Subject: Response to Request for Additional Information
Southeast County Landfill, Hillsborough County
Capacity Expansion Section 8
Certification of Construction Completion
Permit No. 35453-009-SC
Jones Edmunds Project No. 08449-020-01

Following our meeting on June 14, 2006 to discuss the Section 8 Certification of Construction Completion Report (Report), you had requested some additional information to be submitted to our office to assist you with completion your approval of the Report. The additional information that you requested is listed below.

HILLSBOROUGH COUNTY
SOUTHEAST COUNTY LANDFILL
SECTION 8 SITE A
LEACHATE PIPE SETTLEMENT CALCULATION
FIGURE 2. PROFILE "A"

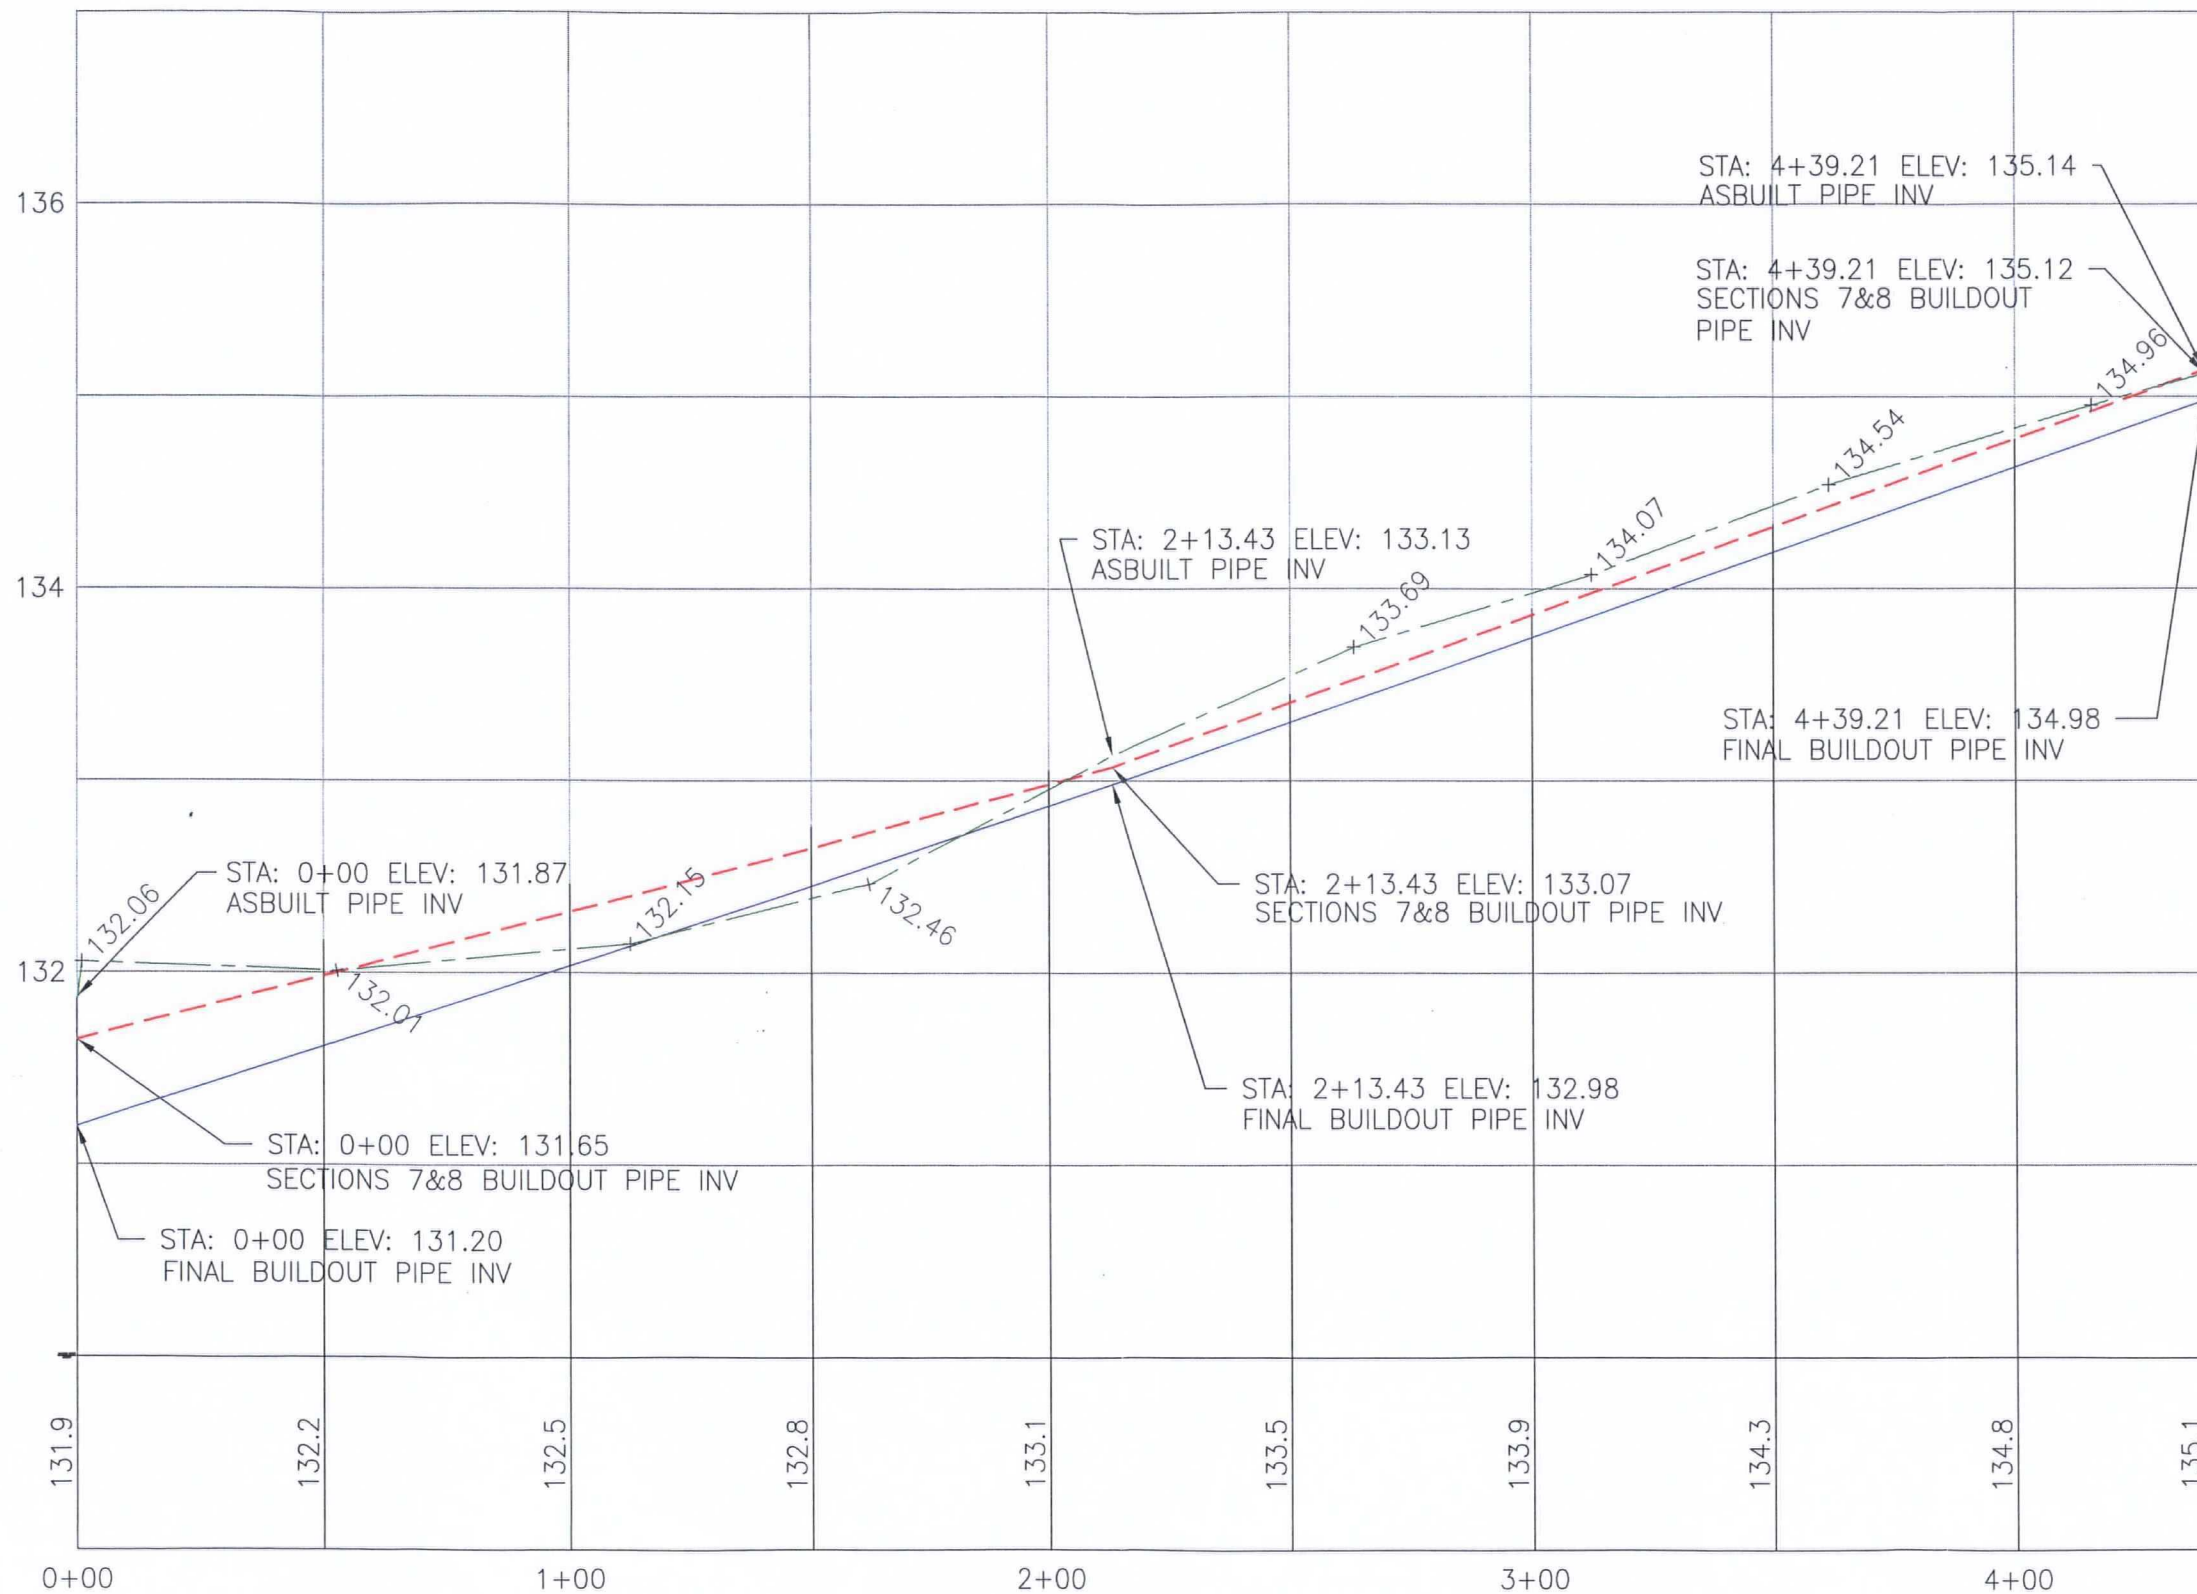
Comment 8) Please provide a Section 8 pipe profile for each leachate collection line with settlement estimates (Refer to the Department's Comment Number 4.a) .

Per our conversation yesterday, I checked the pipe profiles to make sure that the as-built pipe elevations were used as a starting reference elevation. They are. (refer to Sec8Pipe Profiles calcs.pdf)

From the as-built elevations, the settlement numbers computed by SCS Engineers were used to determine the post-settled elevation for Section 7&8 Buildout and Site "A" Buildout.

The as-built pipe survey has numerous individual elevations and we have an exaggerated vertical scale shown on the profile hence the "wavy" profile. We only have three settlement points (as shown on the Sec8Pipe Profiles.pdf). We connected the three points with straight lines therefore there may be places in between the post-settlement points where the settled profile has the "appearance" of being "above" the initial as-built pipe profile.

235SR_{LC}

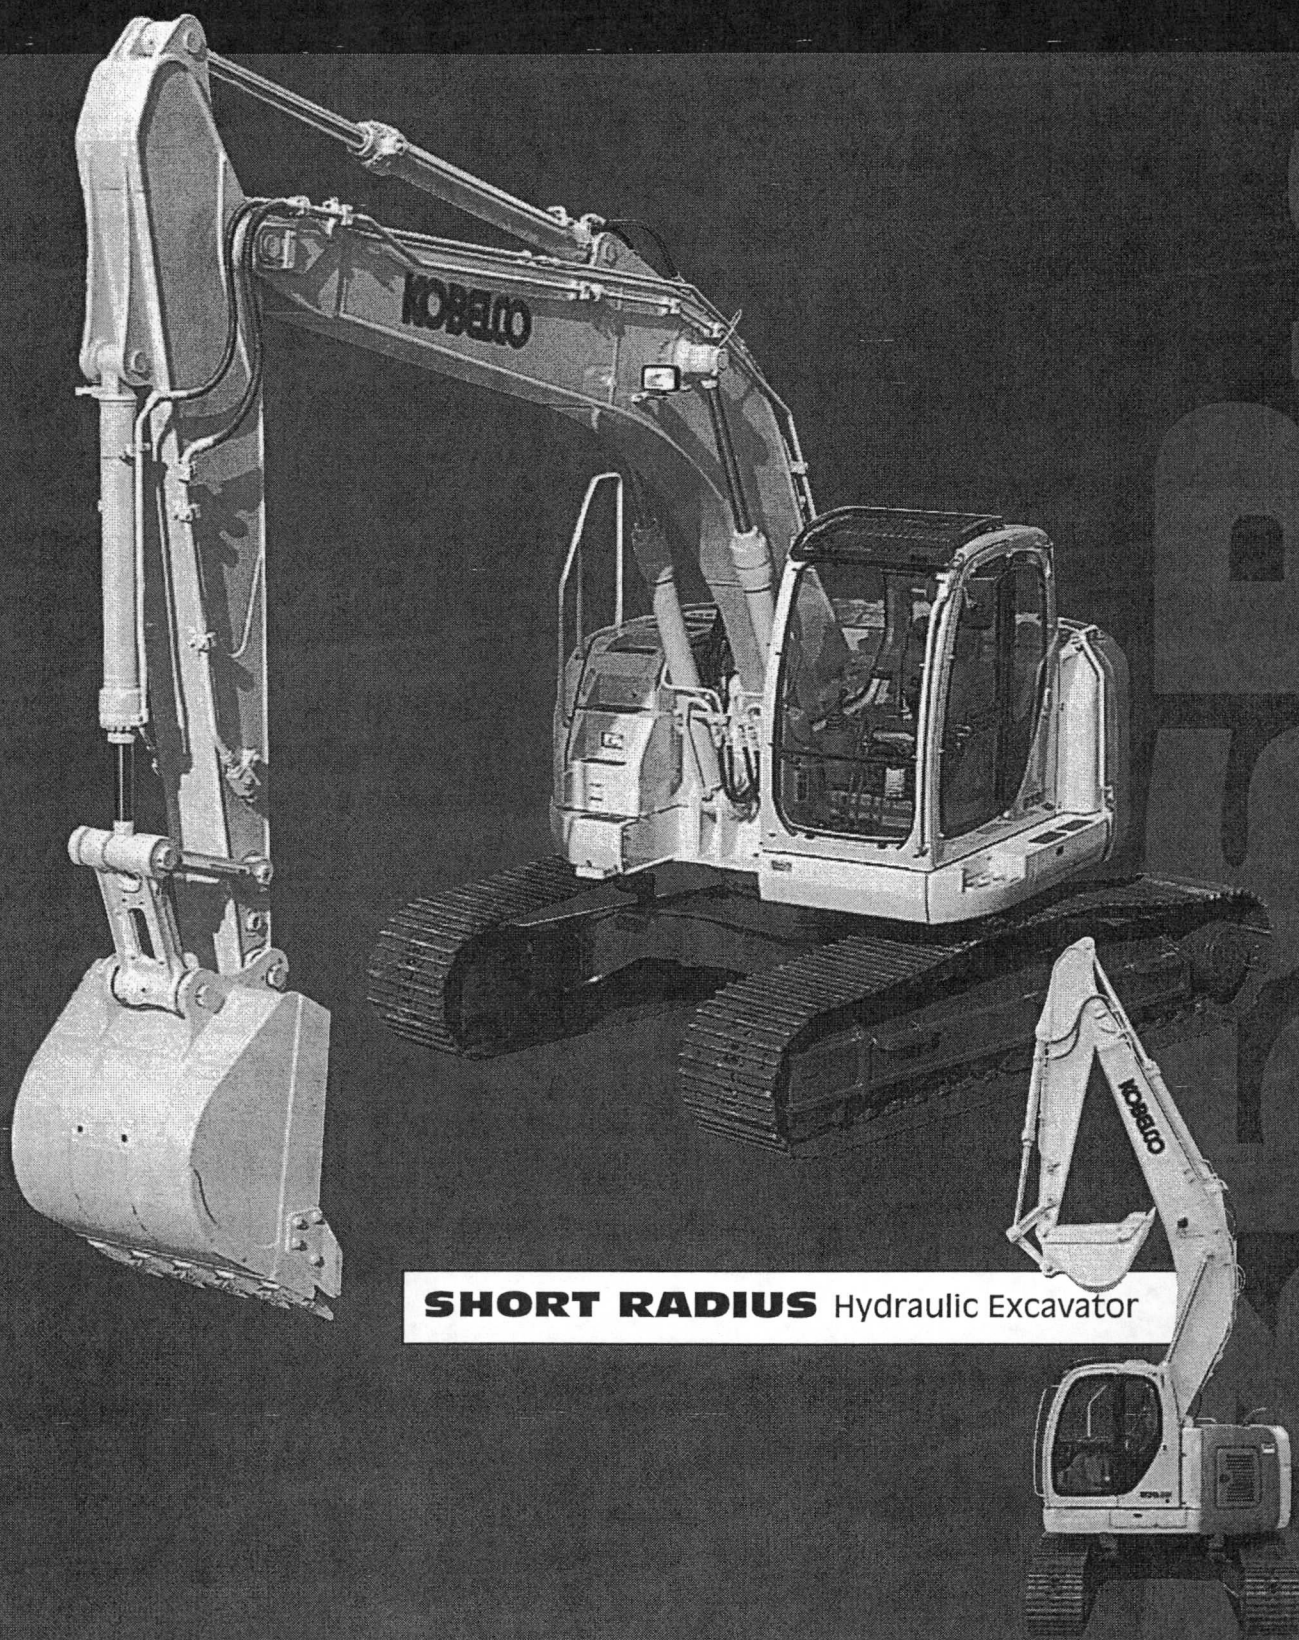
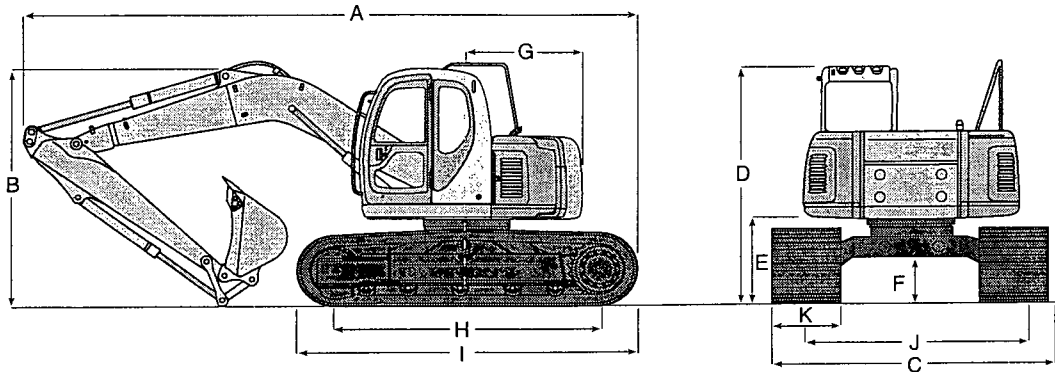
Comment 9) Please verify that the excavator shown in the photograph dated 11/01/05 is "low ground pressure" (Refer to the Department's Comment Number 9.a).

Response 9: The ground pressure of the Kobelco Model 235SR LC excavator shown in the photograph dated 11/01/05 has a ground pressure of approximately 5.6 pounds per square inch (psi). For comparison, the John Deere 700H LGP (Low Ground Pressure) dozer that was used to spread the drainage sand across Section 8 has a slightly higher ground contact pressure of 5.5 psi. Therefore, the excavator shown in the photograph dated 11/01/05 is similar to a "low ground pressure" dozer. Please refer to the documentation of the Kobelco 235SR LC and John Deere 700H LGP vehicles provided in Attachment 6
